Rezoning Transportation Analysis

Petition Number: #2022-099

Date	Description
11-28-22	First Review (IW)

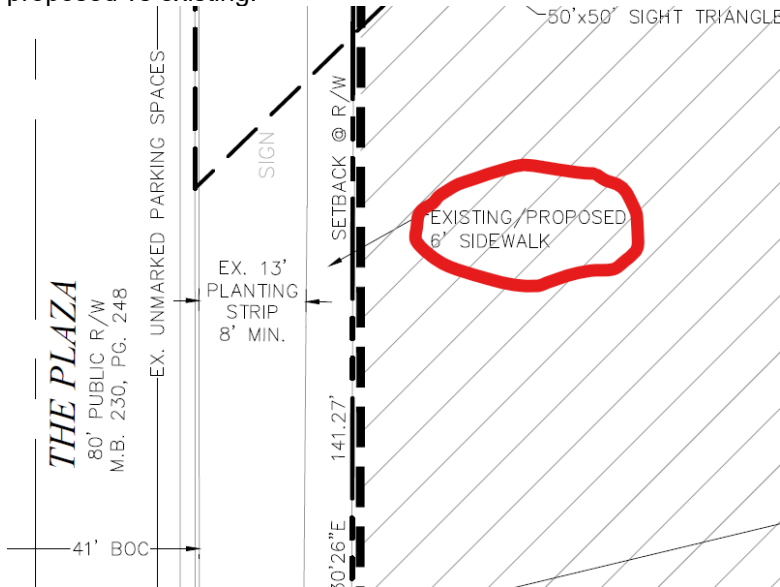
4. Revise site plan and conditional note(s) to commit to dedicate 2 feet of sidewalk utility easement behind proposed sidewalk along Commonwealth Avenue and The Plaza. The site plan shall label and dimension sidewalk utility easement.

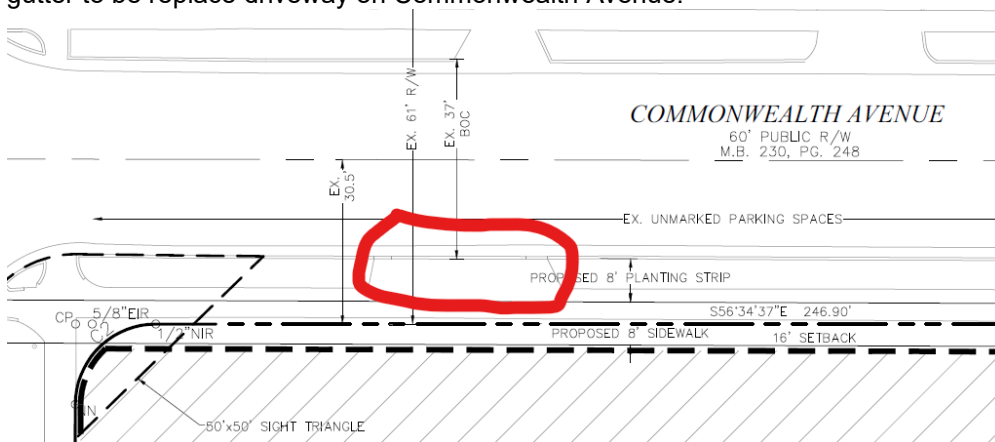
5. Revise site plan and conditional note(s) to specify what portion of the sidewalk along The Plaza will be proposed vs existing.
